<b>PROPERTY INFORMATION</b>	
<b>ADDRESS</b>	13090 Hopewell Road
<b>DISTRICT, LAND LOT</b>	2/2 1036, 1037
<b>OVERLAY DISTRICT</b>	Rural Milton Overlay District
<b>EXISTING ZONING</b>	AG-1 (Agricultural)
<b>PROPOSED ZONING</b>	R-3A (Residential)
<b>ACRES</b>	47.1145
<b>EXISTING USE</b>	Single Family Residence
<b>PROPOSED USE</b>	73 single family residential lots

**COMMUNITY DEVELOPMENT RECOMMENDATION – OCTOBER 24, 2018**

**RZ18-13 – DENIAL  
VC18-07 – Part 1- WITHDRAWAL  
VC18-07 Part 2 - DENIAL**

Prepared by the Community Development Department for the  
City of Milton Planning Commission Meeting on October 24, 2018

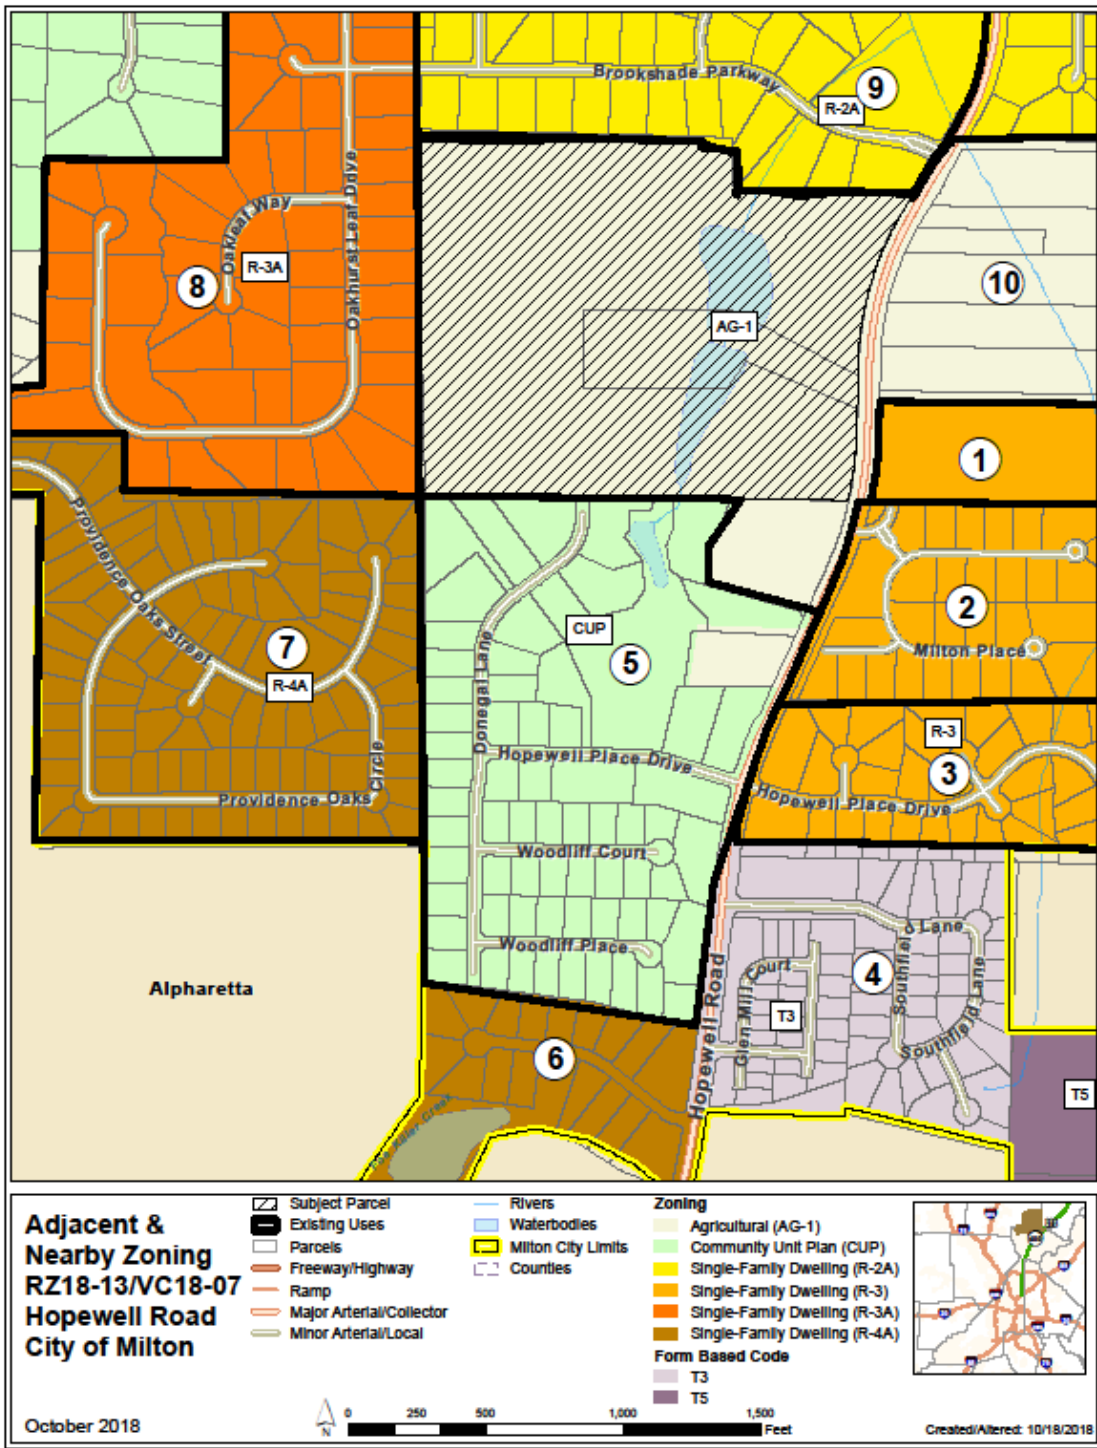
The proposed 73 lot subdivision proposes minimum 18,000 square foot lots with the largest being 1.12 acres and an average of 24,660 square feet. The proposed lots on the west range from 18,666 to 21,909 square feet which are inconsistent with the adjacent lots within Brookshade Subdivision to the west which are developed with minimum 27,000 square foot lots. The proposed lots on the northern portion range in size from 18,666 square feet to 27,220 square feet but are primarily around 18,666 square feet which are inconsistent with Brookshade where lot sizes are primarily 27,000 square feet with some up to one acre or more. Lots on the south, range from 18,666 square feet up to 38,365 square feet but primarily around 20,000 square feet in size which are inconsistent with Vickery Crest. The most northern lots in Vickery Crest are minimum one acre based on the lack of gravity flow for the sanitary sewer within Vickery Crest. The remainder of lots within Vickery Crest are between 15,000 square feet and 20,000 square feet in size. To the west are scattered single family homes zoned AG-1 as well as undeveloped R-3 (Residential) with one acre lot (with common area) adjacent to Hopewell Road. Therefore, it is Staff's opinion that the proposed development is not suitable based on adjacent and nearby properties.
